ADDENDUM NO. 2

DATE: FEBRUARY 12, 2016
TO: ALL PLAN HOLDERS OF THE:
OAK CANYON BOOSTER STATION REHABILITATION
PROJECT
FROM: DAVID GITTLESON – CITY OF MORGAN HILL *Use for D6.*
SUBJECT: ADDITIONS/CHANGES

ON SHEET M002, DETAILS E AND F, REPLACE CALLOUT:

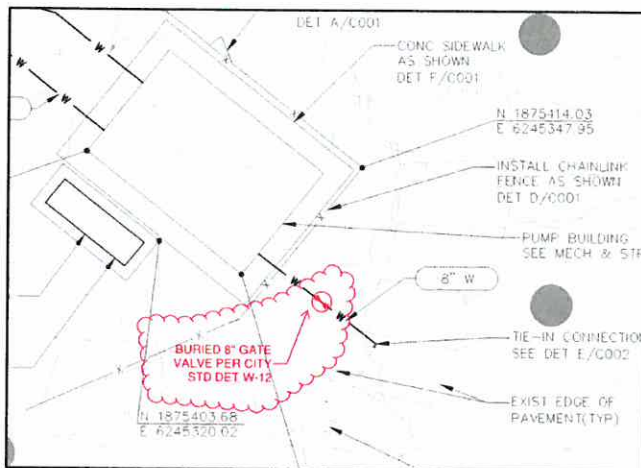
PIPE PENETRATION DET B/M003

WITH:

PIPE PENETRATION DET I/M003
